Tehran Cement

Raw Mill – 6

Mill Audit Report

Raw Mill : 6
Date of Inspection : 24.08.10

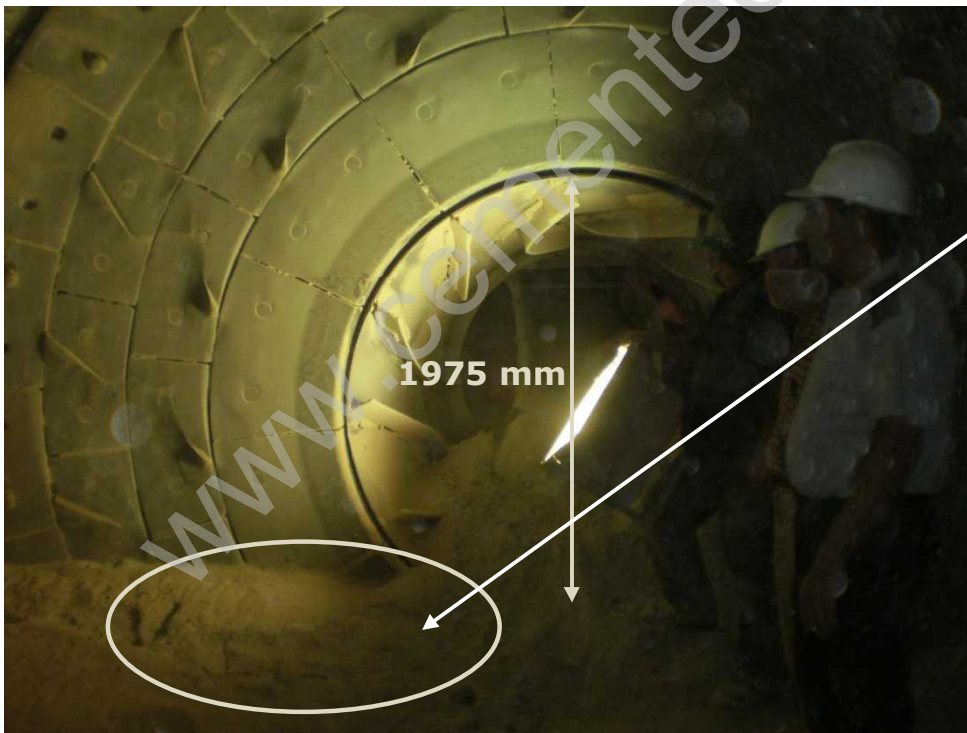
- ✓ Feed analysis indicates that performance of the Horizontal impactor is not consistent, high variation observed between two samples.

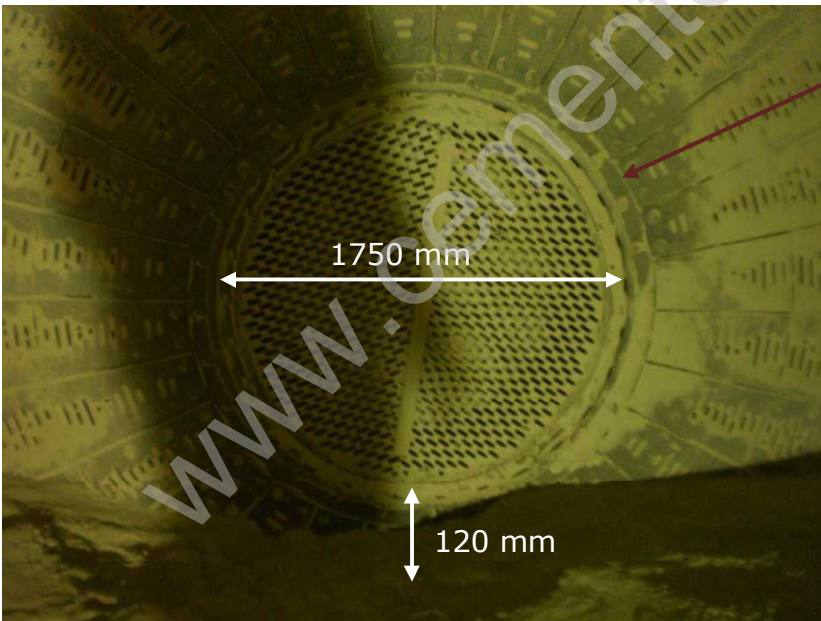
Classifying Liners - Liners are in better condition.

Outlet Diaphragm
- Liners condition is good.
- Slot size measured 10 mm.
- Thickness measured 50 mm

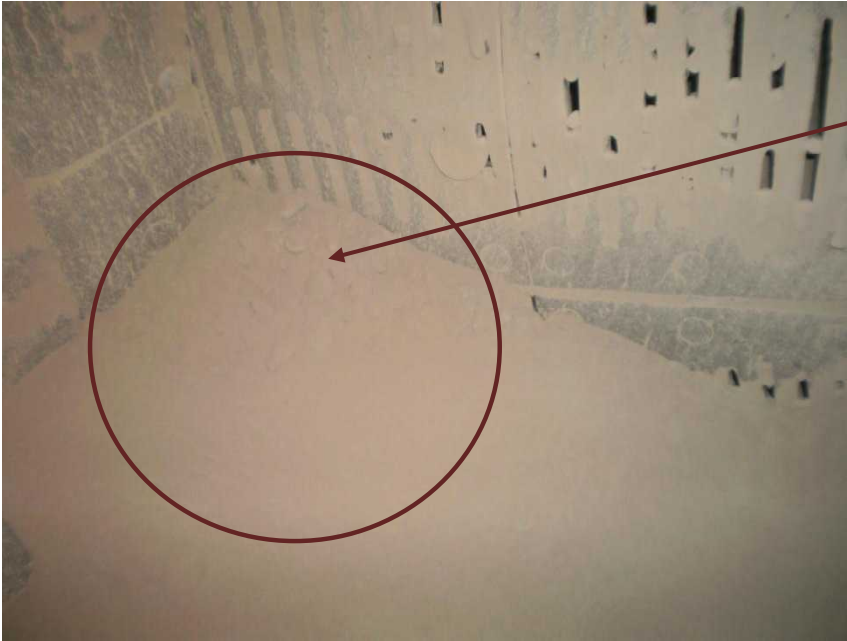
Bigger particles are accumulating at the Discharge end.

- Regular cleaning of slots to be done due to frequent choking of the slots.

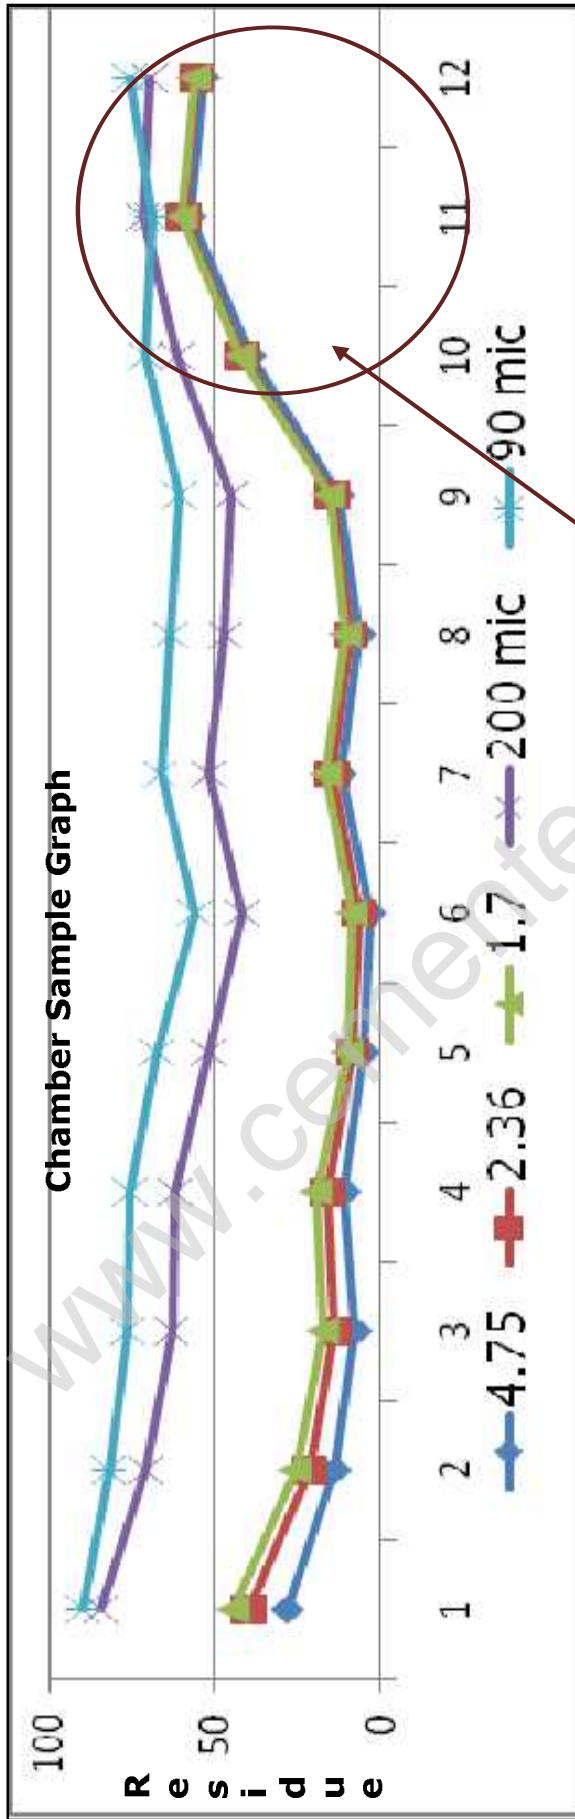
Slots of the Discharge grates observed choked by coarse particle.
